<b>Notice of Allowability</b>	Application No.	Applicant(s)
	08/801,464	FUNAKOSHI ET AL.
	Examiner Clark F. Dexter	Art Unit 3724

**EXAMINER'S AMENDMENT**

FIG. 6A

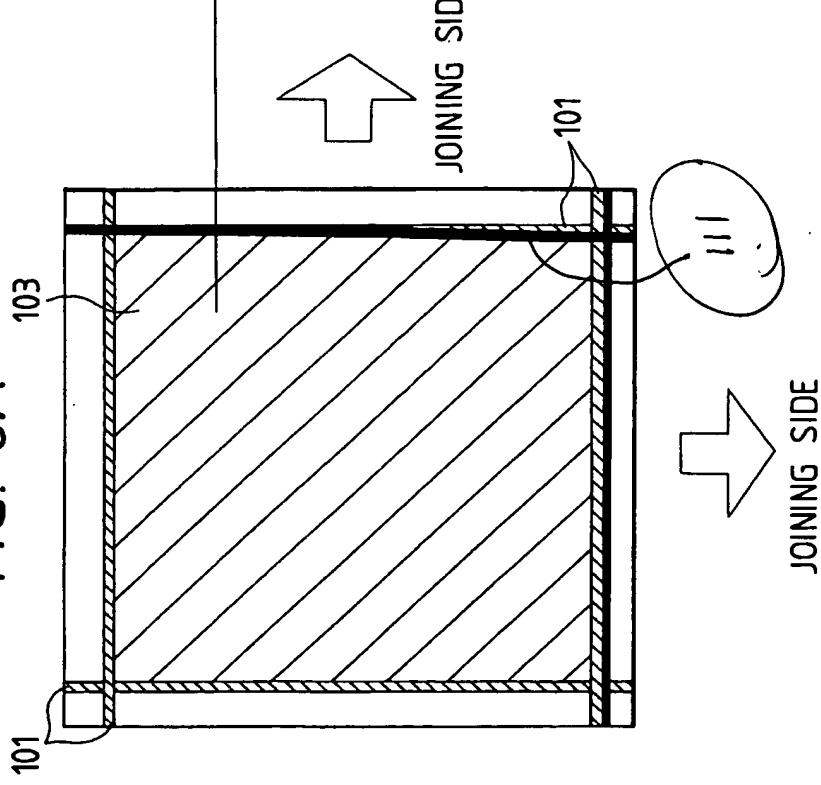
In Figure 6A, numeral 111 will be added to indicate the bold cut line (see attached drawing correction).
